FLEX-PLI-GTR Development

Review Dynamic Calibration Procedures

7th FLEX-TEG meeting December 8, 2008
BASt, Bergisch Gladbach, Germany

Flex-GT Rubber Stiffness

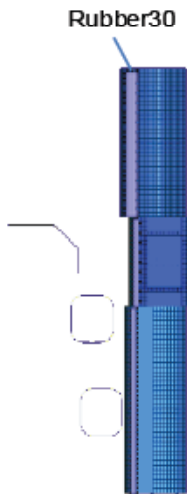
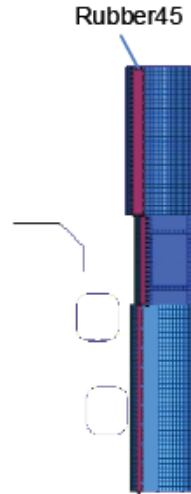
- **Valid concern! How to control the response of the skin?**
- **Quantify influence skin property on test results: study JARI: negligible difference between 30&45shoreA**
- **Linear guided procedure: if the test fails, how do you know the source: honeycomb, skin/flesh, or impactor?**
 - Linear guided impactor does not solve the problem
 - Linear guided impactor gives additional problem: honeycomb

- **Facultative skin-flesh performance test based on dynamic stopper block test procedure**

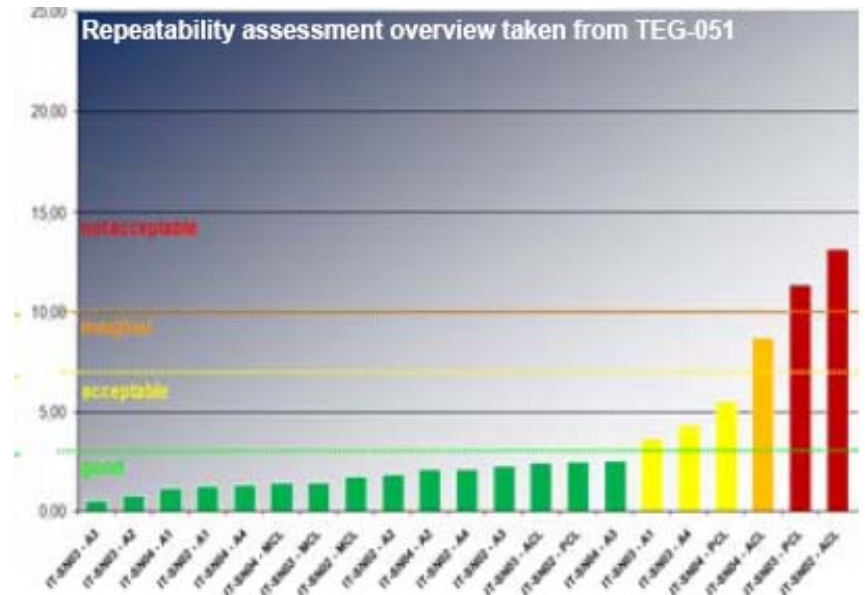
TEG-062 'Influence of stopper and neoprene / rubber sheets on test results disproportionately high (independent from stopper material control)'

- **Concern is addressed by introduction of two counter measures to control impact pulse consistency:**
 - Knee-tibia accelerometer
 - Stopper block dynamic test
- **Not valid. The GTR dynamic calibration results are highly reproducible.**
 - 'Disproportionately high' is based on what data?
